City of Albuquerque

RE: REVISED DRAINAGE PLAN FOR THE TAYLOR RANCH LDS CHURCH
(E-11/D23) ENGINEER'S STAMP DATED FEBRUARY 23, 1990

DRAINAGE INFORMATION SHEET

GRADING AND DRAINAGE PLAN

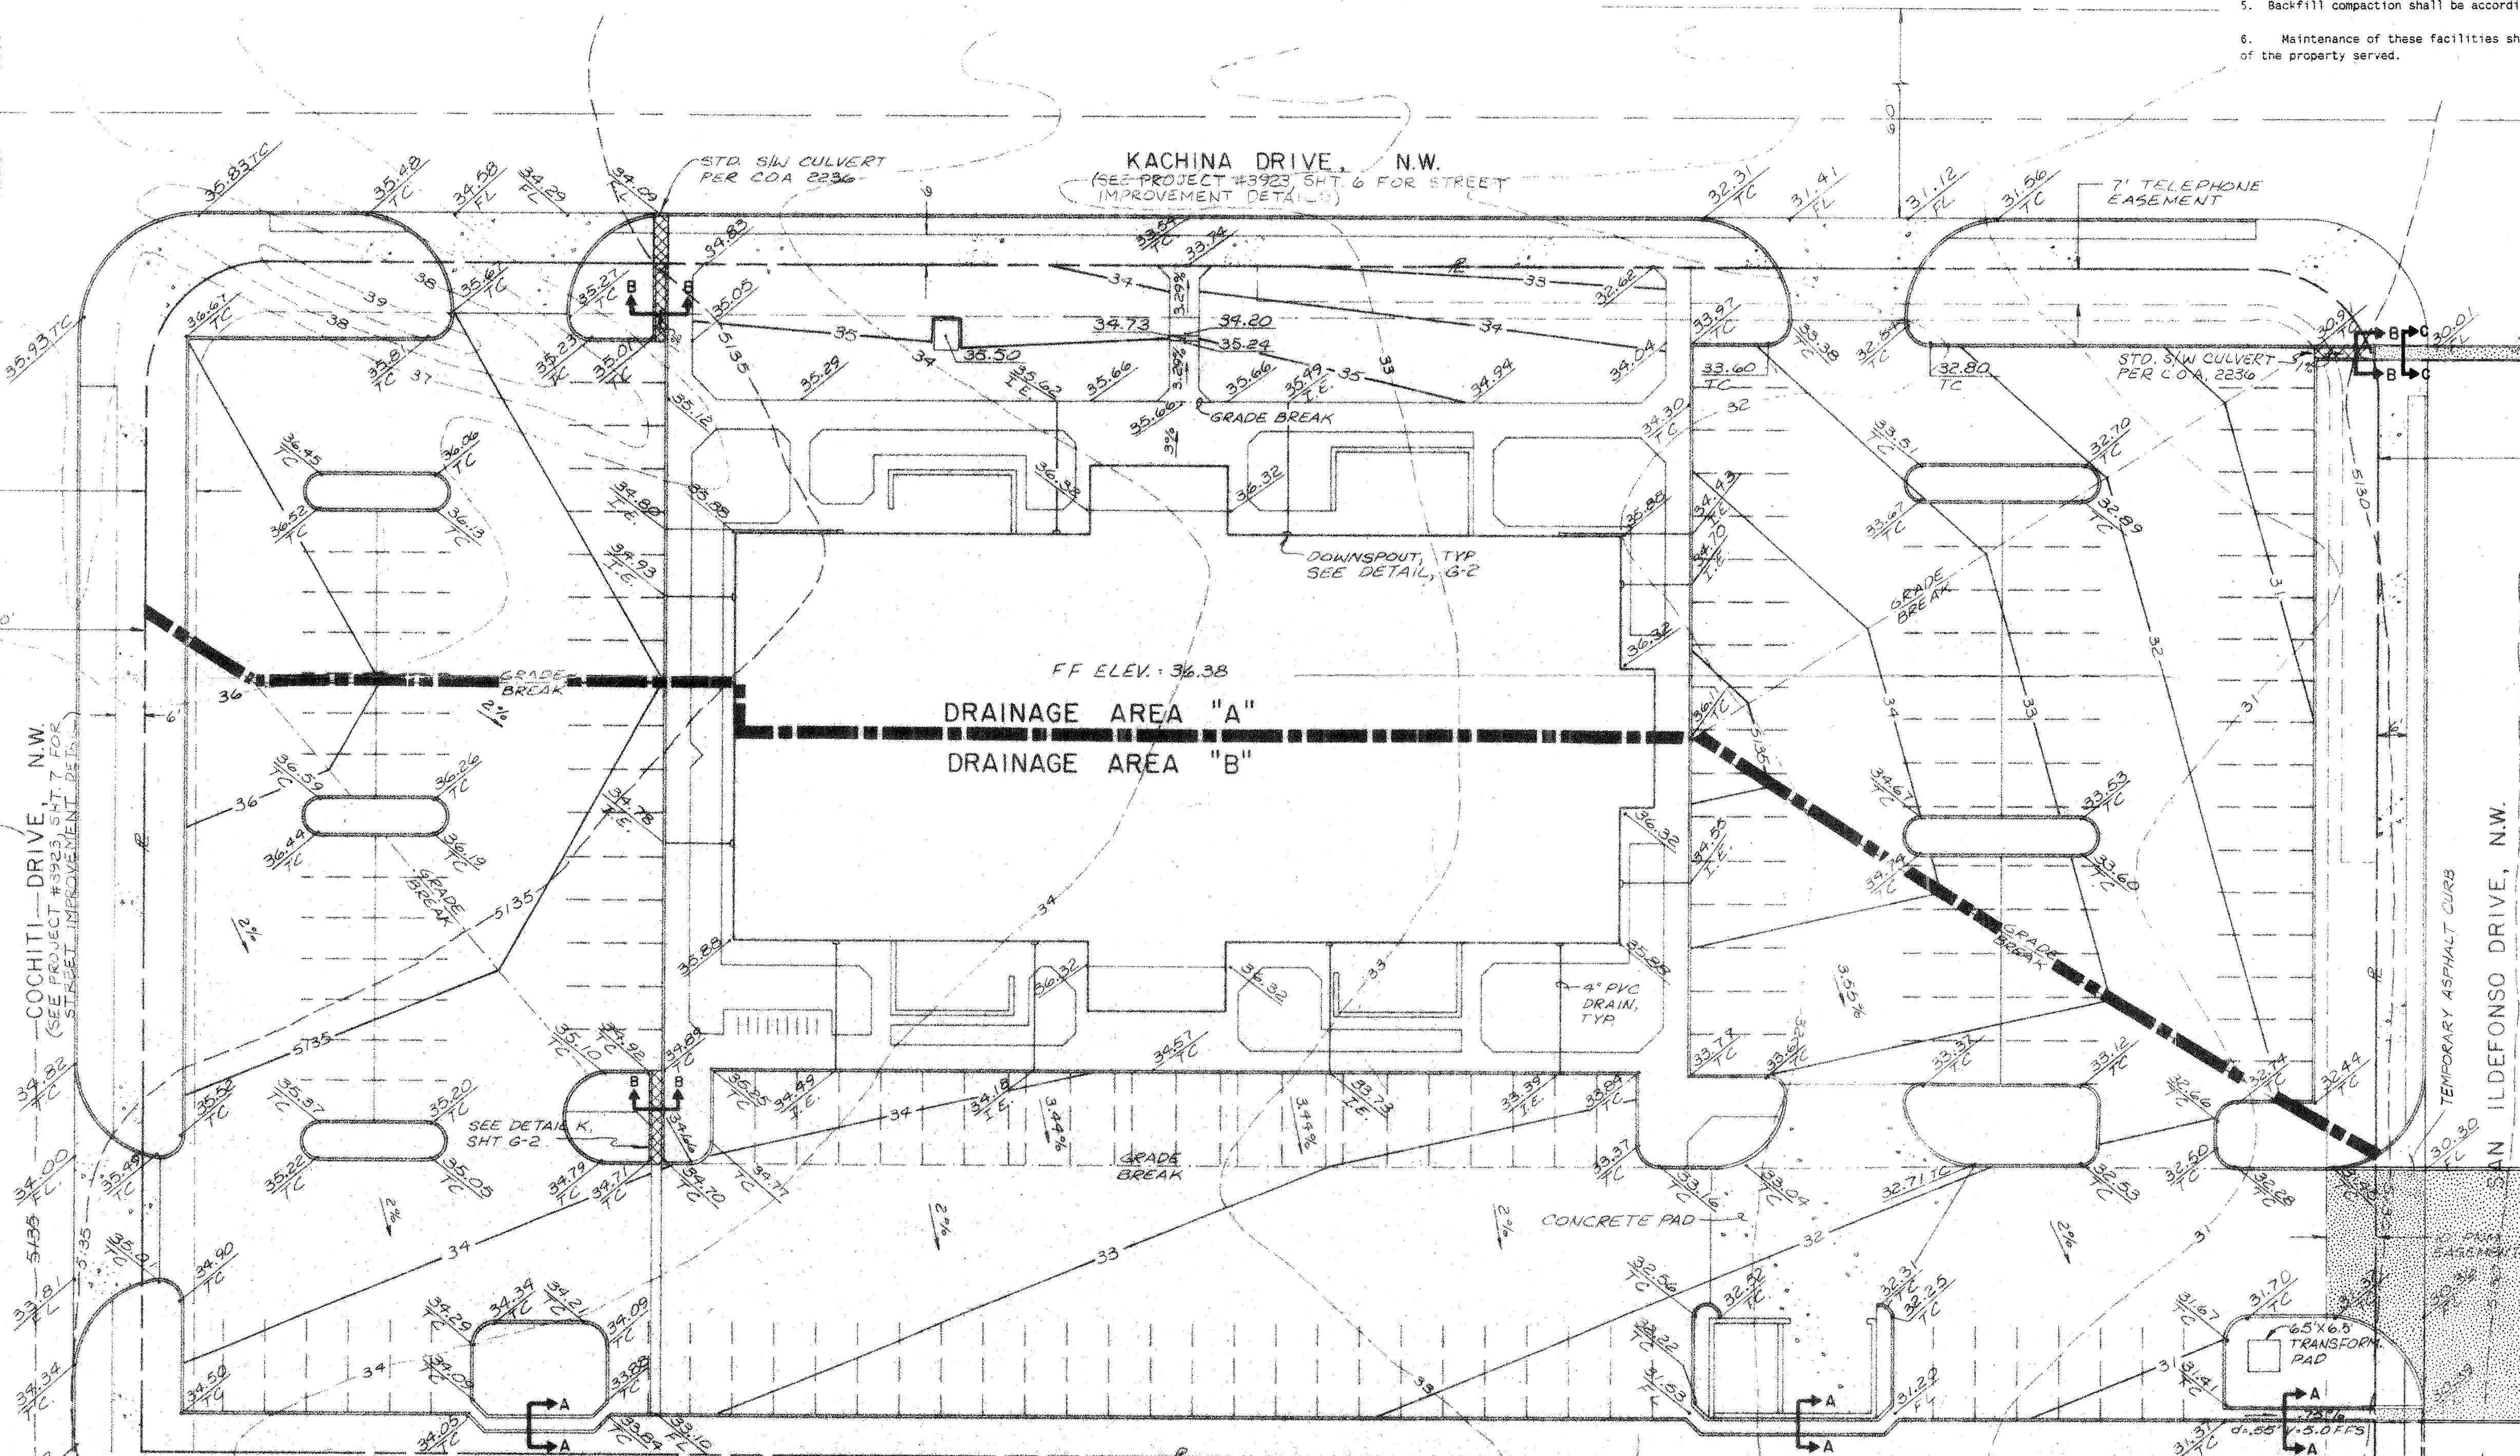
Based on the information provided on your submittal of February 23, 1990, the above referenced plan is approved for Building Permit.

Be advised that if the site construction takes place prior to the SAD for San Idelfonso Drive, the proposed sidewalk culverts into the street can be incorporated with the SAD work. If the street goes in first, then the S.O. #19 process will be used.

A separate permit is required for construction within the City right-of-way. A copy of this approval letter must be on hand when applying for the excavation permit.

Please attach a copy of this plan to the construction sets prior to sign-off by Hydrology.
